**CERTIFICATE OF APPROPRIATENESS**

**Property:** 1330 Cortlandt Street, Lot 22, Block 168, Houston Heights Subdivision. The property includes an altered historic 4,301 square foot, two-story wood frame single-family residence and a detached two-story accessory structure situated on a 9,900 square foot (75' x 132') interior lot.

**Proposal:** New Construction – *Revision*

The applicant now proposes to revise this COA by adding solar panels to the south facing portion of the roof structure.

**PROPOSED SOLAR PANELS**  
BIRD'S EYE VIEW

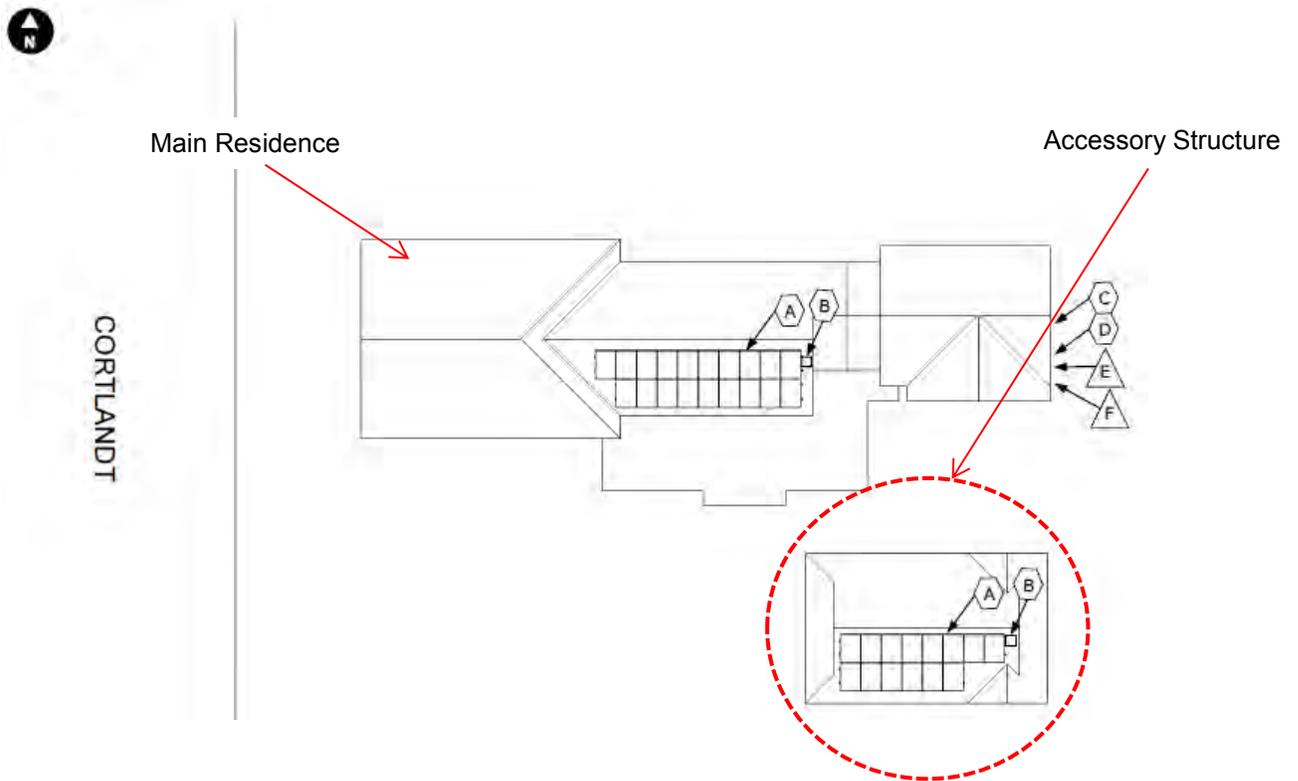
1330 Cortlandt solar panels – no objection when solar panels are placed on the non-contributing portion of the structure

15. 1330 Cortlandt St, New Construction-Accessory Structure *Revision - Support. Question: why are they required to get HAHC approval for this? "Roofing" material is clearly omitted from the HAHC jurisdiction. Therefore, solar panels on top of a roof should be as well, right? Also I do not understand why Staff is using the criteria for alterations, since this is clearly a "new construction"*

1330 Cortlandt (solar panels) — No Objection — On non-contributing sections, mostly out of sight
